Access Compliance Report

Public Rights-of-Way

(Pedestrian Signals)

Intersection ID: N/A	Main Street:	Cross Street: N/A	Location: N/A
ADA ID: 17AE8B559F3F	Signal Type: One Push Button-APS	Overall Compliance: No	Severity Score: BTN 1: N/A BTN 2: N/A No BTN: N/A
Codes/Mitigation Info/Possible Solution		Field Measurements/Component Compliance

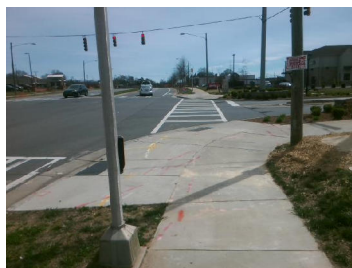
Surveyor Notes: OUT OF SERVICE

PROW/ADA: TMUTCD 4e.08, R209.1, TMUTCD 4e.10, MUTCD 4e.08, R104.2,

Possible Solutions: Replace Signal Push Button With APS Button on New Post. Remove & Relocate Sign.
